MISSISSIPPI DEPARTMENT OF TRANSPORTATION

SECTION 904 - NOTICE TO BIDDERS NO. 5863

SUBJECT: Readvertisement

PROJECT: STP-0010-01(150) / 106964301 – Jackson County

MISSISSIPPI DEPARTMENT OF TRANSPORTATION	
ITS TRAFFIC CONTROL PLAN	
NOTES AND PLAN	
PROJ. NO HSIP-0010-01(150)	
JACKSON COUNTY	
WORKING NUMBER	TC-2
FILENAME: TC-02.DGN	SHEET NUMBER
DESIGN TEAM GS&P	CHECKED
DATE	DATE
10/16/15	10/16/15
REVISION	REVISION
BY	BY
TG	TG

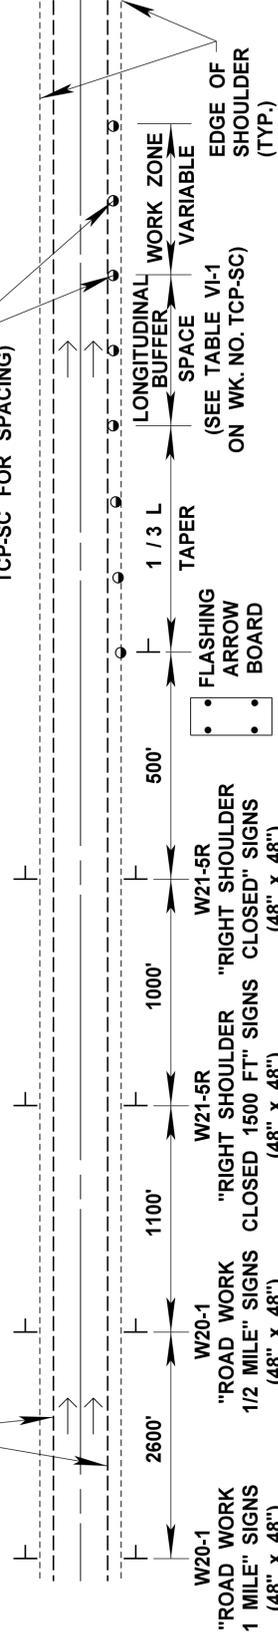
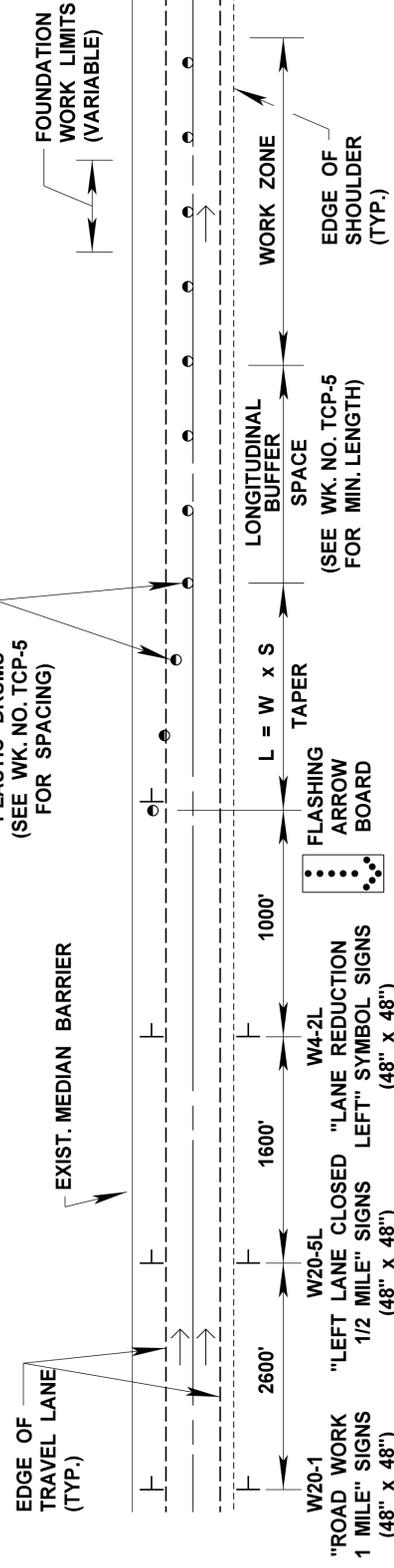
Bidders are advised that note (1) of Lane Closures on Sheet Number 26 of the plans is in error. Closures will be limited as follows and as stated in notes (2&3):
